**Discussion of North Lafayette Paving Options
Pavement Widths and Special Assessments**

June 21, 2016

Discussion of North Lafayette Paving Options Pavement Widths and Special Assessment

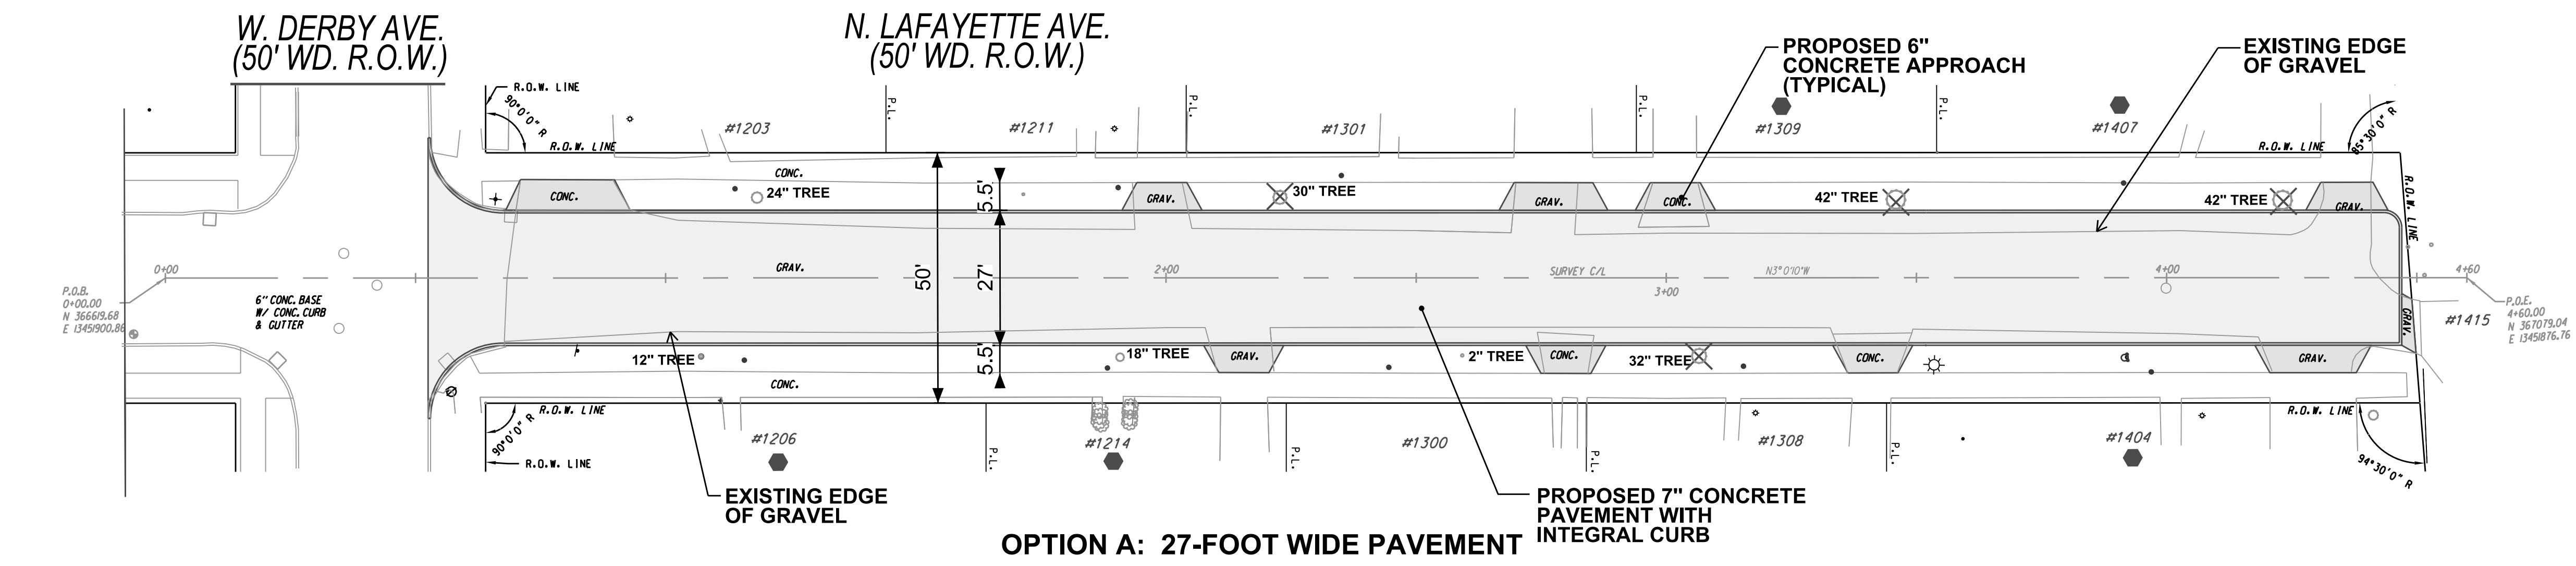
After reviewing the three proposed options that had been previously presented to the city commission on March 21 (Attachment 1), the fire department concurs with the recommendation from the engineering division to choose option "A". The standard 27-foot wide proposal for North Lafayette Avenue from West Derby Avenue to the north lot line of lot 189 will not negatively impact fire department emergency operations.

Engineering recommends the standard 27-foot wide layout shown in option A. City special assessment policy dictates that this is the city's standard roadway width, and will allow for parking on both sides of the street.
